<b>Docket Number:</b>	18-IRP-01
<b>Project Title:</b>	Integrated Resource Plan
<b>TN #:</b>	259659
<b>Document Title:</b>	Response to CEC Staff Questions on TID IRP
<b>Description:</b>	Response to CEC Staff Questions on TID IRP
<b>Filer:</b>	Meredith Monroe
<b>Organization:</b>	Turlock Irrigation District
<b>Submitter Role:</b>	Applicant
<b>Submission Date:</b>	10/23/2024 8:35:13 AM
<b>Docketed Date:</b>	10/23/2024

**Re: Email dated October 8, 2024**

Below are Turlock Irrigation District's (TID's) responses to your recent emails requesting clarification of a few aspects of TID's most recent Integrated Resource Plan (IRP):

Figure 21. Annual Energy Efficiency Savings from TID Programs

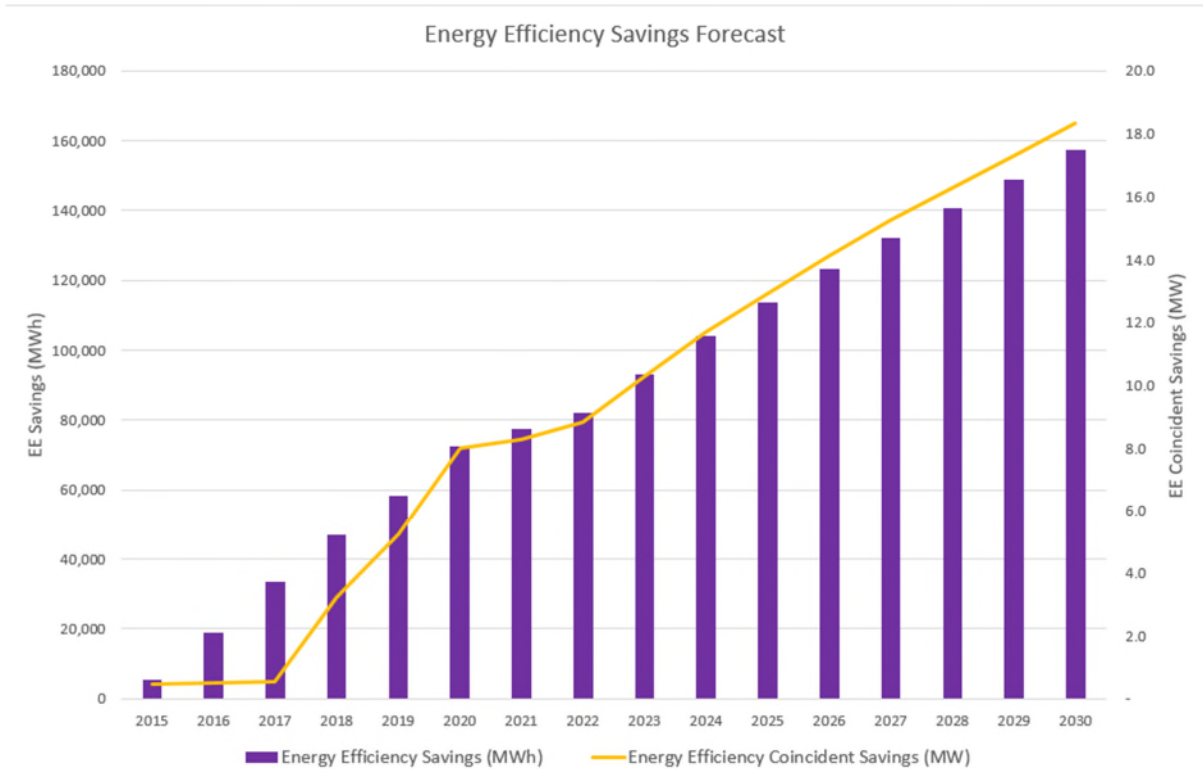
3. **CEC Question:** Can you provide additional historical data on cumulative energy efficiency (EE) savings for years 2015 through 2022? This info could be provided as a separate figure for 2015 through 2022 or a replacement for your Figure 21 showing data for 2015 through 2030. This would help support the conclusion of meeting the cumulative EE savings of 140 GWh for TID in 2030 relative to the 2015 baseline as shown on page A-21, Table A-11 in *Revised SB 350 Doubling Energy Efficiency Savings by 2030* (Revised SB 350 Report), California Energy Commission (October

- a. **TID Response:** TID has opted to provide an updated Figure 21, which includes historical EE savings for 2015-2022 alongside our latest EE targets from 2023-2030. Summing up the cumulative EE impacts out to 2030 yields approximately 157 GWh of cumulative savings in 2030, which is above the SB 350 2030 target for TID of 140 GWh of cumulative savings. The updated figure can be seen below.
